WG37 - Reworking Lid for Rear Fuse Box (Workshop Campaign)

Vehicle type: **918 Spyder**

Subject: **Lid for rear fuse box**

Removing cover

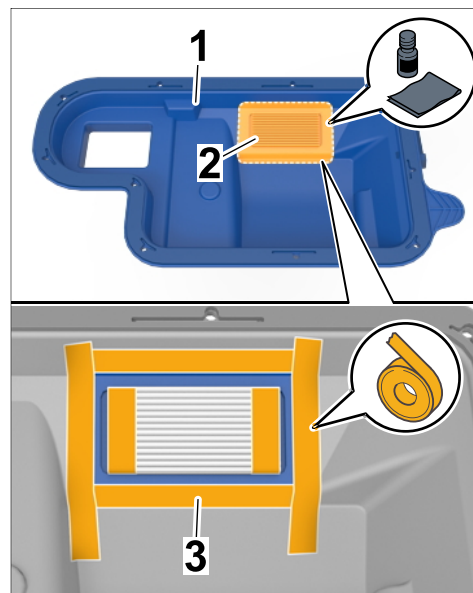
- 1.1 Remove engine cover ⇒ *Workshop Manual '108319 Removing and installing engine cover'*.
- 1.2 Loosen and unscrew fastening screws ⇒ *Removing cover -2-* on the lid for the fuse box ⇒ *Removing cover -1-*.
- 1.3 Remove lid for fuse box ⇒ *Removing cover -1-*.

Preparing lid

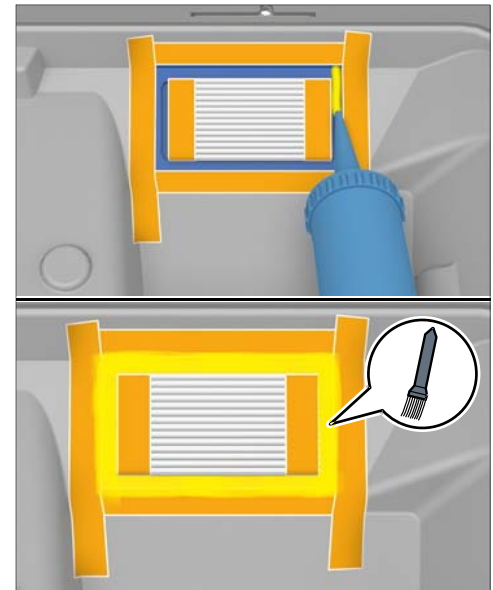
- 2.1 Clean the lid of the fuse box ⇒ *Preparing lid -1-* in the area to be sealed around the heat dissipator ⇒ *Preparing lid -2-* using cleaning solution.
- 2.2 Mask the marked area with adhesive tape ⇒ *Preparing lid -3-*. To do this, affix adhesive strips approx. 10 mm away from the heat dissipator as shown.

- 2.3 **Apply body sealant** to the marked area using a suitable applicator gun, e.g. **V.A.G 1761/1 Multi-press telescopic spray gun** or **V.A.G 1628 Hand-cartridge gun** and spread it out with a brush. Make sure that the joint area between the heat dissipator and lid is completely sealed with body sealant. Re-apply body sealant and spread it out again if necessary.

- 2.4 Pull off the adhesive strips you affixed earlier.

Cover for relay carrier

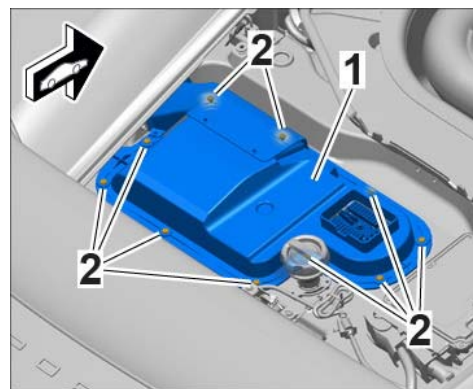
Cover for fuse box and relay carrier fitted incorrectly or damaged

- Water leaking into the fuse box and relay carrier.
- ⇒ Check seal on the cover. If the seal is damaged, the cover must be replaced.
- ⇒ Ensure absolute cleanliness when fitting the cover.
- ⇒ Clean the joint face of the cover on the cross member.
- ⇒ Clean the seal on the cover.
- ⇒ If seal is damaged and needed to be replaced, please create a separate PQIS line and code to part ID "9783" Relay Carrier. Part Number 918.610.112.02

- 3.1 Install lid for fuse box ⇒ *Cover for relay carrier -1-*.
Screw in and tighten fastening screws ⇒ *Cover for relay carrier -2-* uniformly.

Tightening torque 2.5 Nm (2 ftlb.)
